Product Change Notification

Product Change Notification: PCN-23-170097
PCN Date: 27-MAR-23
Customer: Future Electronics(0000080100)
Location: WORLDWIDE
Agreement: Agreement Unknown

DEUTSCH Size 20 SF Pin & Socket Terminal New Capacity Tooling, ID 4

DEU Size 20 Pin & Socket New Tool

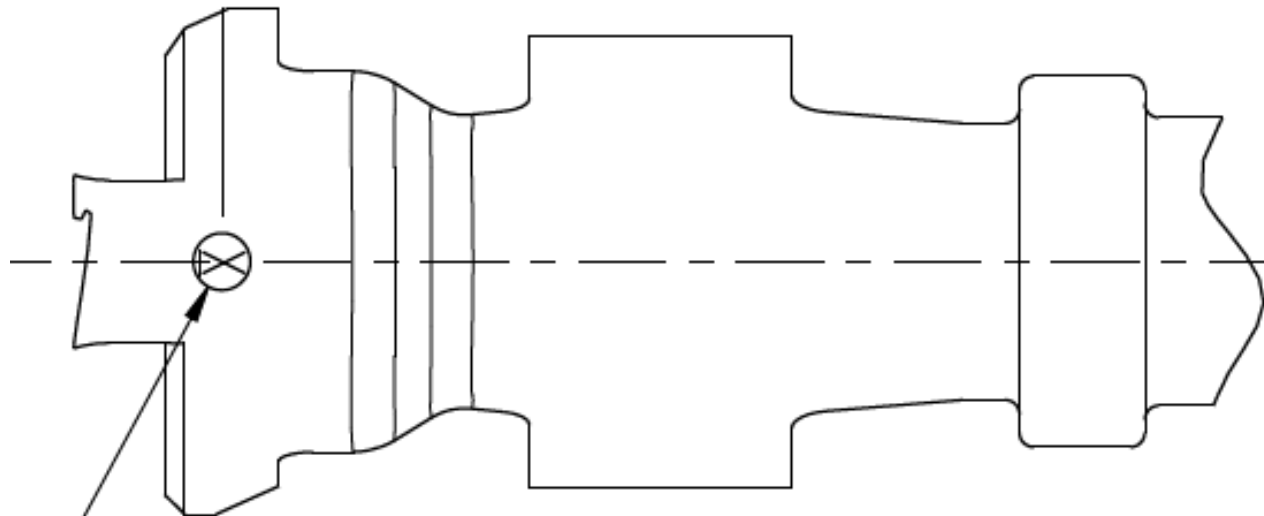
Tool ID location
bottom side of
insulation grip

Tool ID = 4
